Access Compliance Report Public Rights-of-Way (Curb Ramps)

Main Street: TIGERTAIL_DR		Cross Street: SILVER_FOX_RD		Location:	SE
ADA ID: RPRK211206172902	Ramp Type: Type 4 - Parallel	Initial Pass/Fail: Fail	Overall Compliance: No	Severity Score:	15
Codes/Mitigation Info/Possible Solution			Field Measurements/Component Compliance

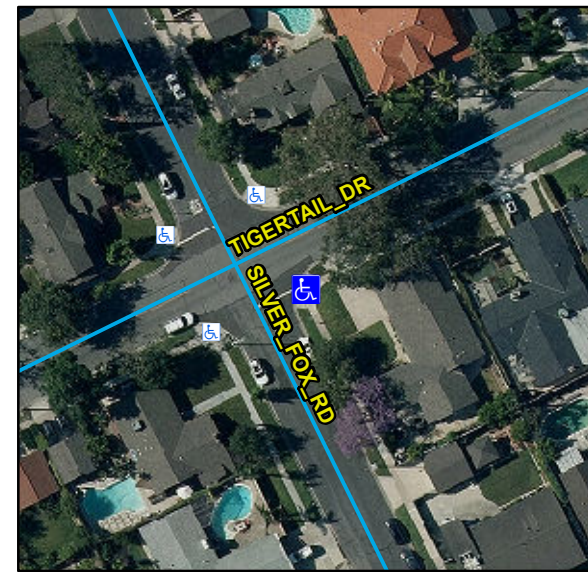
Compliance	Description	Data	Compliance	Description	Data
N/A	Ramp Length LT (in)	113	N/A	Ramp Length RT (in)	113
Yes	Ramp Width LT (in)	127	Yes	Ramp Width RT (in)	127
Yes	Ramp Run Slope LT (%)	3.2	Yes	Ramp Run Slope RT (%)	4.7
No	Ramp Cross Slope LT (%)	3.3	No	Ramp Cross Slope RT (%)	6.4
N/A	Landing Present	N/A	N/A	DWS Provided	N/A
N/A	Landing Length (in)	N/A	N/A	DWS Contrast	N/A
N/A	Landing Width (in)	N/A	N/A	DWS Length (in)	N/A
N/A	Landing Run Slope (%)	N/A	N/A	DWS Full Width	N/A
N/A	Landing Cross Slope (%)	N/A		DWS Offset Type	N/A
N/A	Landing Movement Obstructed?	N/A	N/A	DWS Offset Left (in)	N/A
	Landing Movement Type	N/A	N/A	DWS Offset Right (in)	N/A
N/A	Landing Shared	N/A			
N/A	Clear Space	Yes			
N/A	Clear Space To Crosswalk (in)	N/A			
N/A	Marked Crosswalk 1	No	N/A	Marked Crosswalk 2	No
	Crossing 1 Direction	N		Crossing 2 Direction	W
	Marked Crosswalk 1 Width (in)	N/A		Marked Crosswalk 2 Width (in)	N/A

Remove & Replace Curb Ramp With Two New Directional Ramps or Equivalent.
